NUMBER: S.B. M20-224

DATE: 9-23-80

SUBJECT: FUEL FLOW TRANSDUCER, AEROSONIC PART NO. 32622-6

FIGURE 1

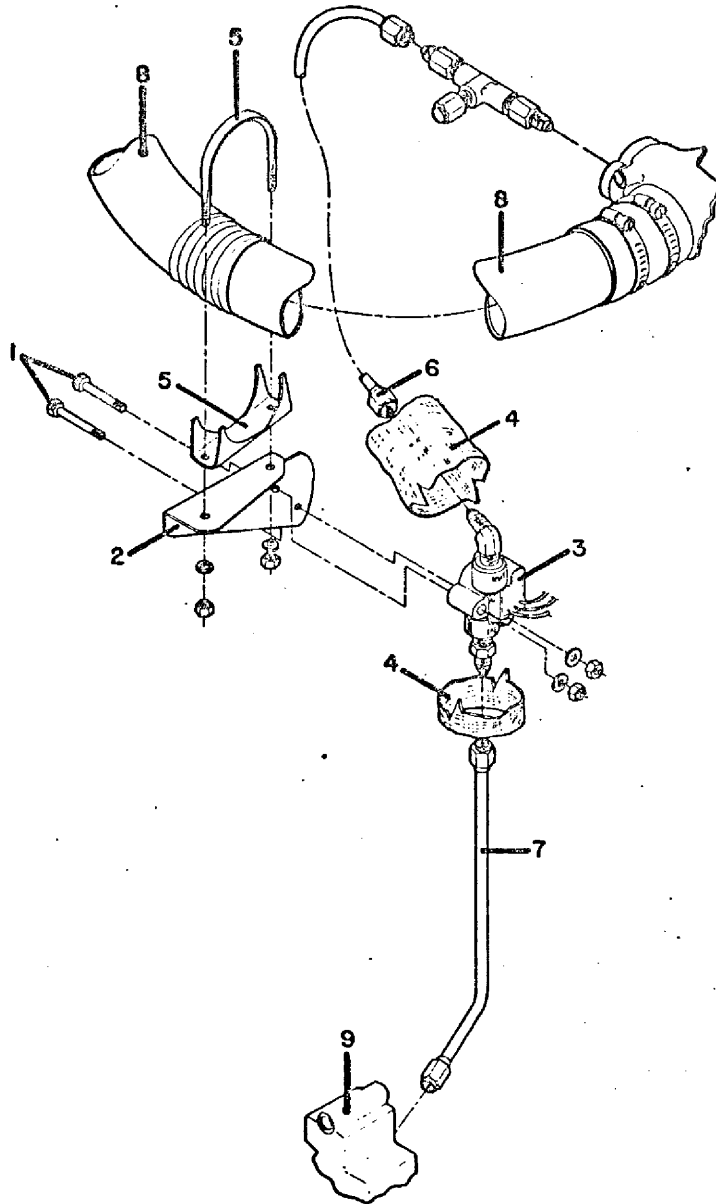
It has been determined that certain transducers manu-
factured by Aerosonic were improperly assembled and on
some installations may leak or come apart during engine
operation. This Bulletin requires inspection and
replacement of suspect transducers on above aircraft
serial numbers.

General: Unless the transducer has been replaced on the
aircraft serial nos. listed above since new,
the transducers must be replaced.

- 4) Loosen the nuts on the C10Y-34-6S clamp assy and rotate bracket and clamp so the back side of the transducer is exposed. Inspect for the name "FLOSCAN" embossed on the backing plate of the transducer housing. If the name "FLOSCAN" is found on unit it does not need replacing.

- 5) If no name is found on the backing plate, the transducer must be removed and replaced with a "FLOSCAN" unit.
 - a. Disconnect the fuel lines from the transducer ports.

- b. Remove sleeving from knife blade type connections and disconnect.
- 6) Install and secure the new transducer and leak check all fuel fittings prior to covering with the firesleeve. Install 45° elbow and union to transducer to a minimum torque of 40 inch/lbs., rotate to index to position. If leak persists, tighten one full turn, do not overrun or back off. Torque fuel line flare nut fittings to 50-90 inch/lbs.
